FINAL DRAINAGE REPORT FOR GLENEAGLE GOLF COURSE RESIDENTIAL INFILL DEVELOPMENT FILING NO. 2

November 26, 2018
Project Number 03524

VR-18-018

DEVELOPED
 CONDITIONS

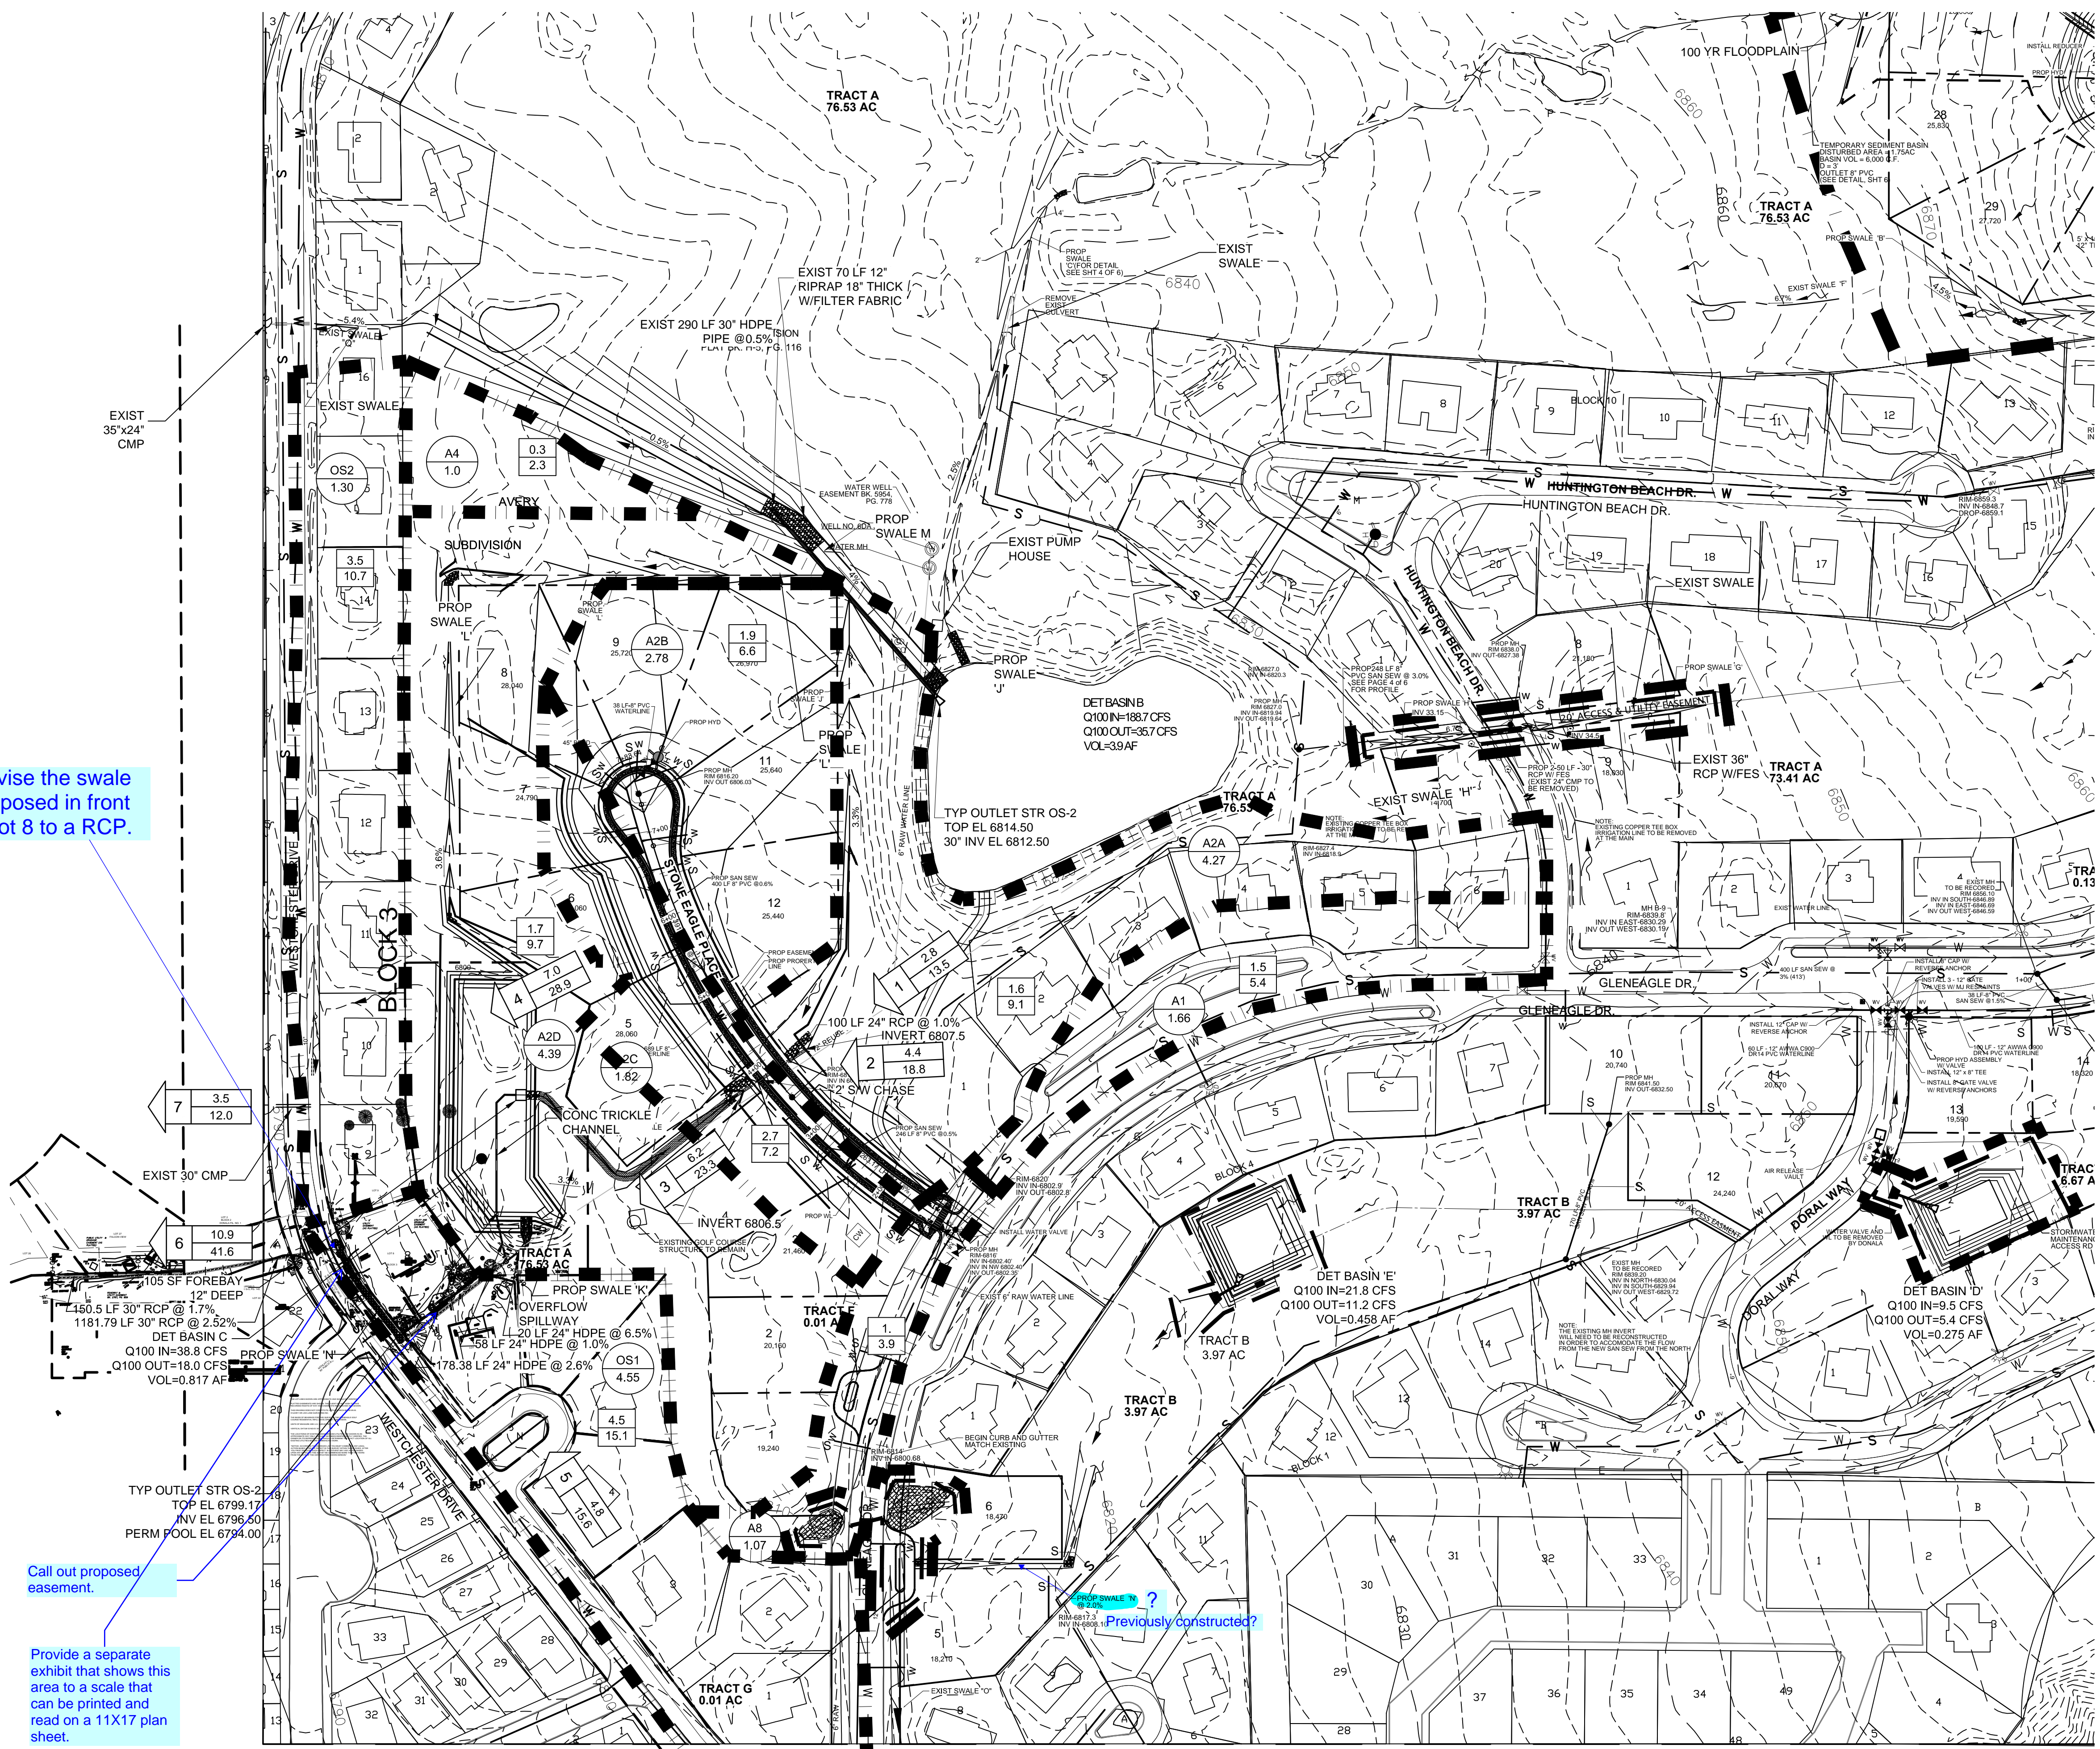
Revise the swale proposed in front of lot 8 to a RCP.

Call out proposed easement.

Provide a separate exhibit that shows this area to a scale that can be printed and read on a 11x17 plan sheet.

Previously constructed?
